ADDENDUM NO. 3**BID CALL NO. T2024-276****ADDITION AND RENOVATION AT BRAMPTON MEMORIAL ARENA**

ADDENDUM NO.03

ADDENDUM NO.04

Addendum #:	M01
Revision #:	1

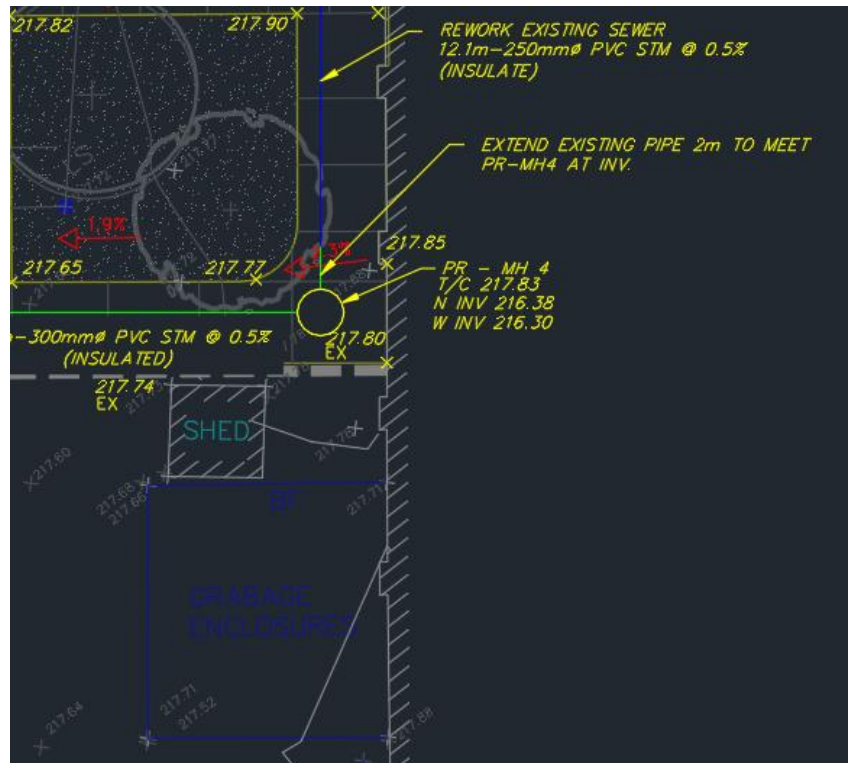
Where the existing sewer pipe is located underneath the existing Garage Enclosure foundation. To be able to re-work the slope of the pipe. We need to know what is the foundation made-up in order to allow the cost to rebuild the foundation. No information provided on the existing garage enclosure.

1. The EF06 is to be connected to the existing pipe.
2. There seems to be a linework discrepancy in CV-2. As per the City provided drawings, the existing pipe runs 24m from existing MH#5 and would require a 2m extension towards PR-MH 4. This would not conflict with the garbage enclosure. See sketch below:

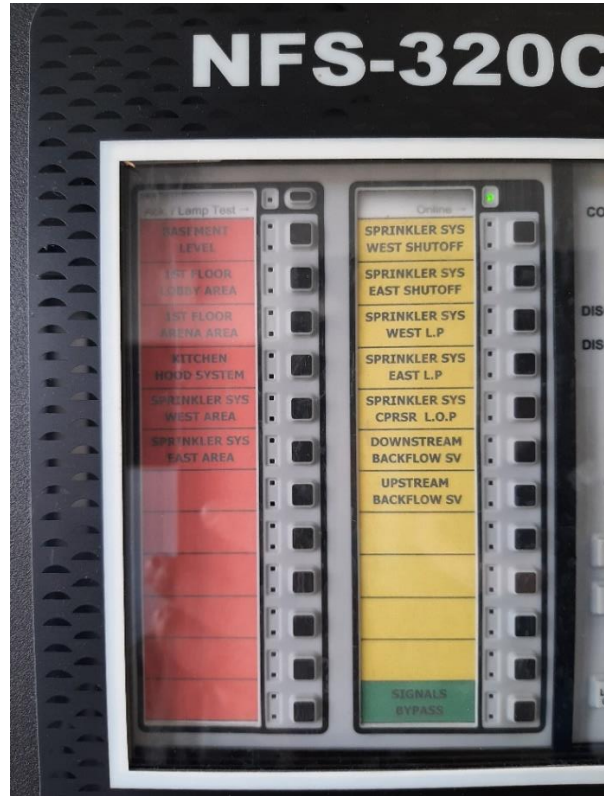
- What is the existing Intrusion system in the Brampton Memorial?
- What is the existing alarm panel model, is there any space to add these new zones on it

- For the scope of this project, only the raceways and boxes for the intrusion system were accounted for.
- This is noted in the drawings refer electrical drawing E40 issued for tender. And refer to the attached pictures for additional information.

SCALE **AS SHOWN** DRAWING No. **M252**

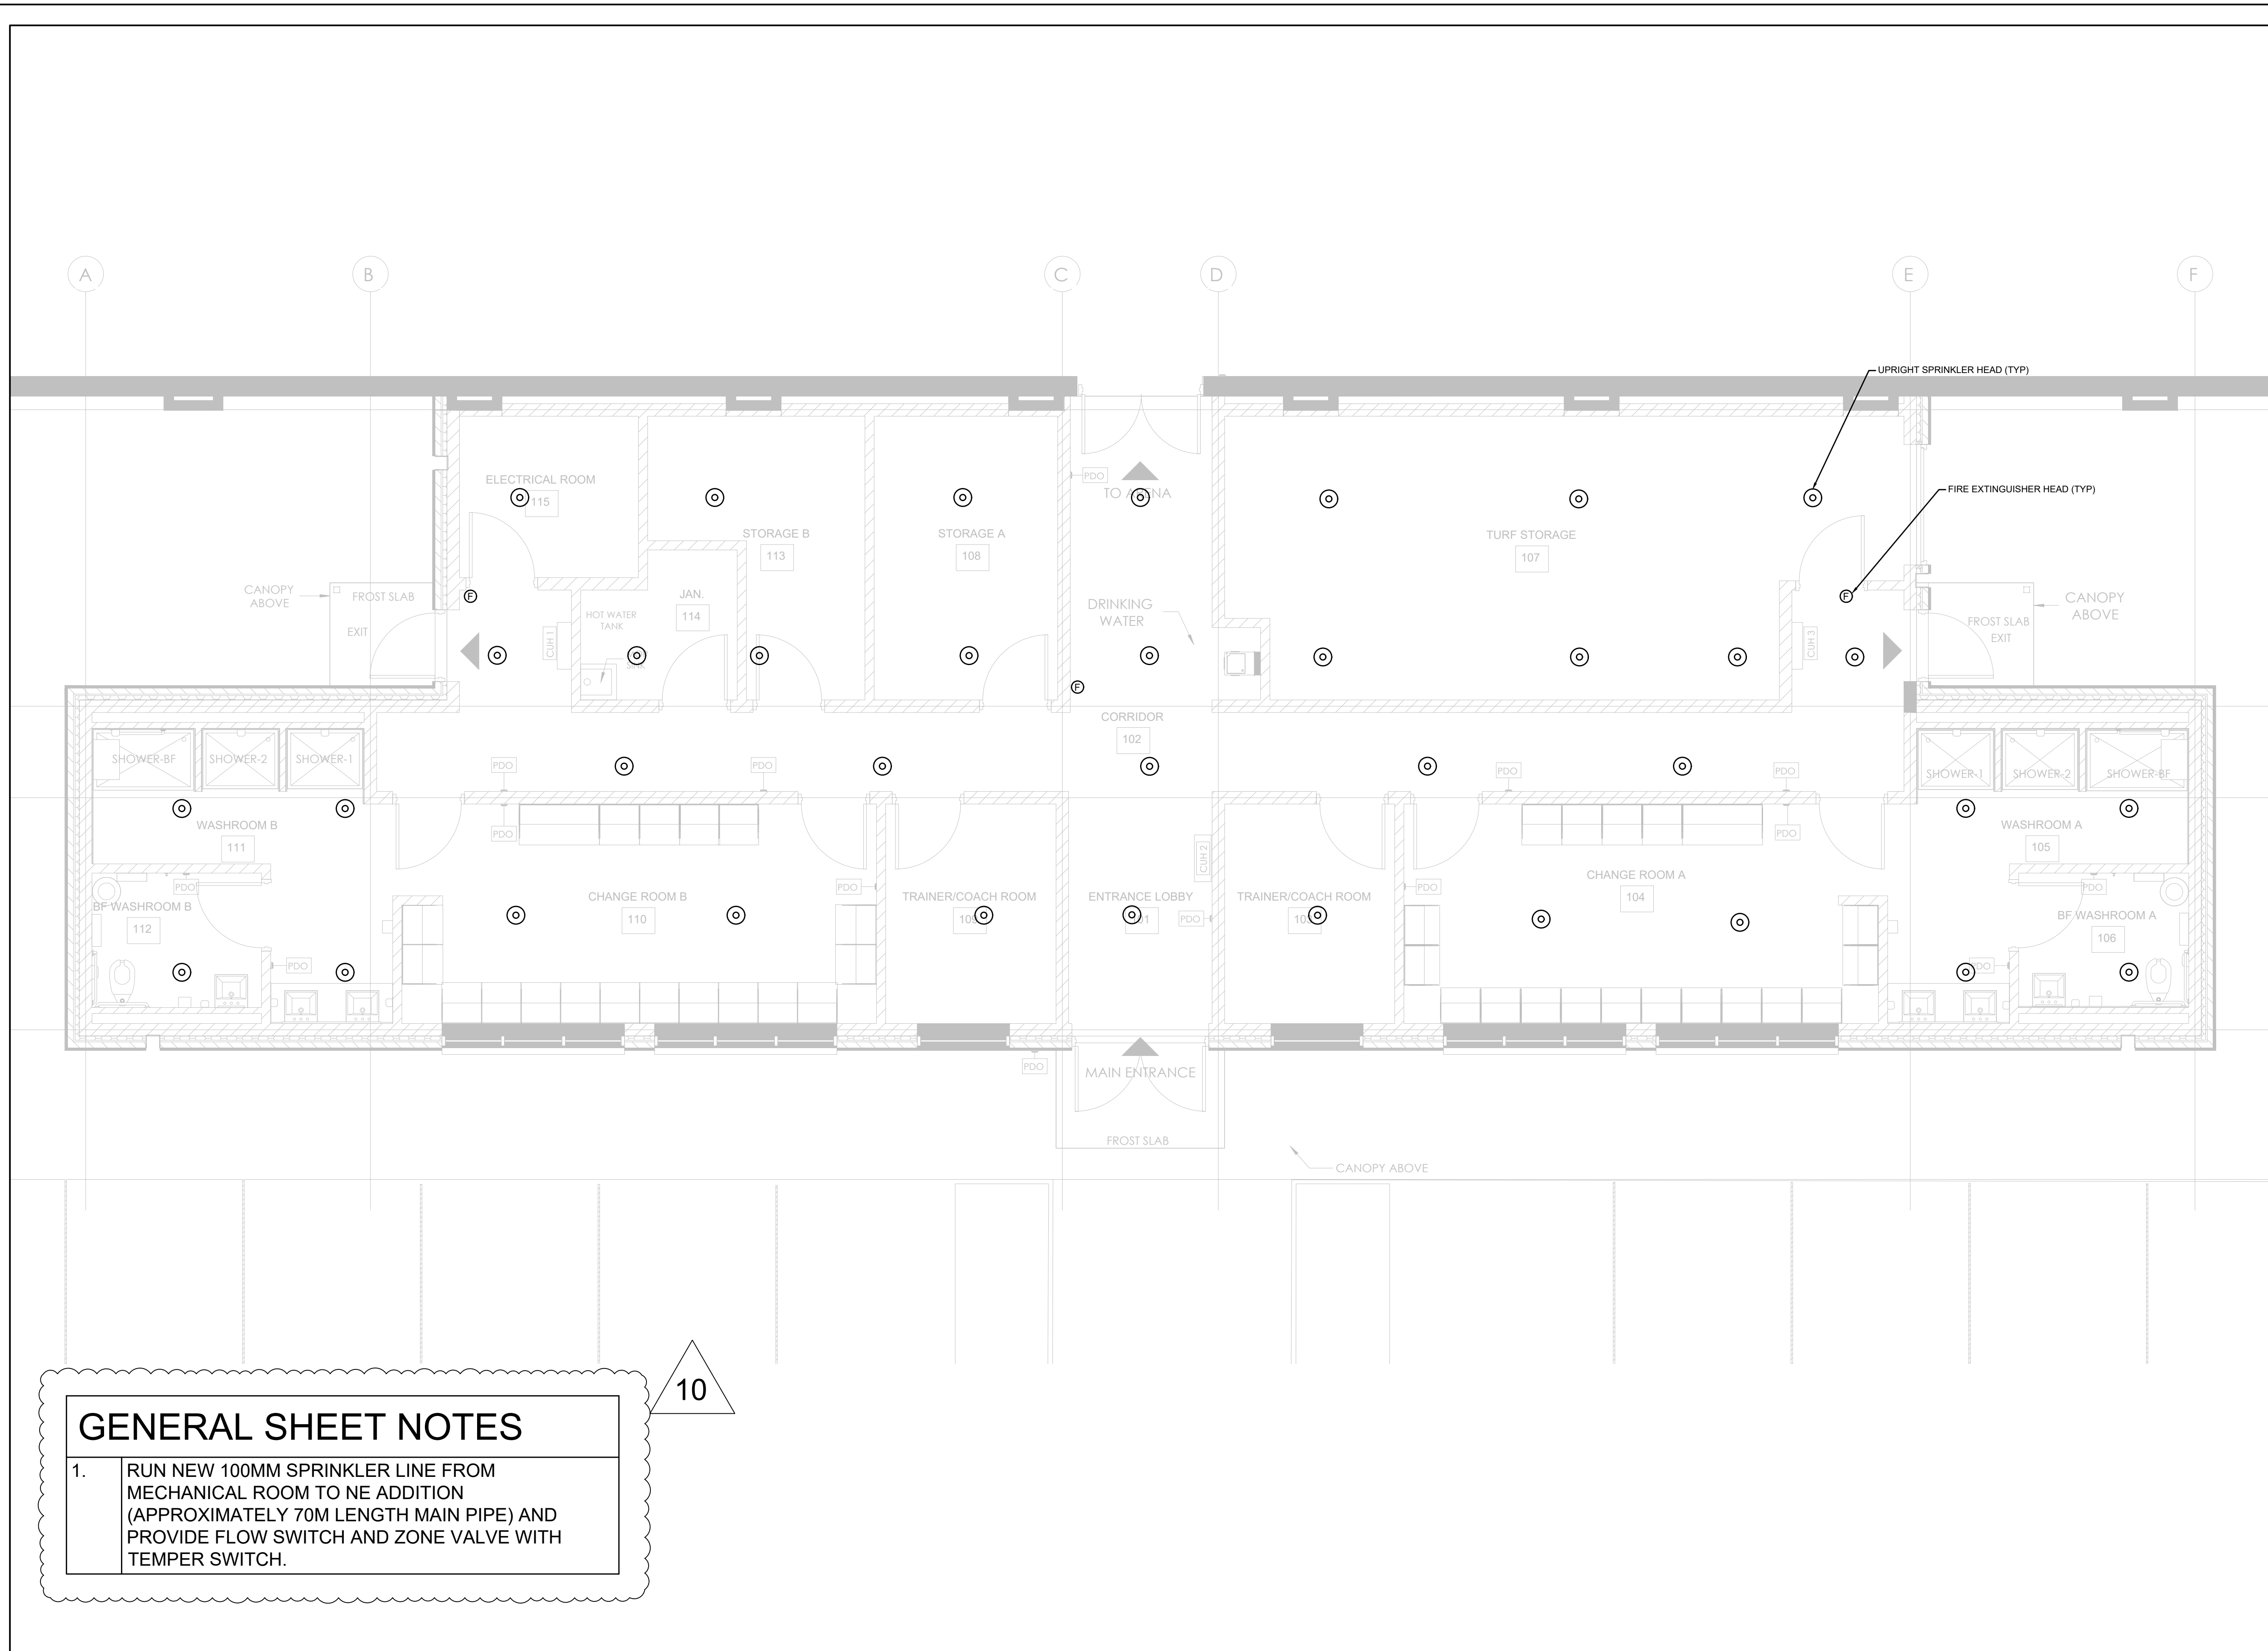
2.3 Question: Please provide larger print size or drawing scale of the Mechanical Drawings since symbols and notes are not clearly legible (ie: M-252).

1. Roof drain drop downs relocated to match architectural changes. See M250.
2. Scupper Drains added on roof plan. See M251.
3. See updated text size on Sheet M252
4. New notes added to M450 to address sprinkler line from existing buildings mechanical room.
5. See updated schedule on M900 for RTU's. Units are available in Canada please contact Issac Mui (Isaac.Mui@jci.com) for further assistance ordering.
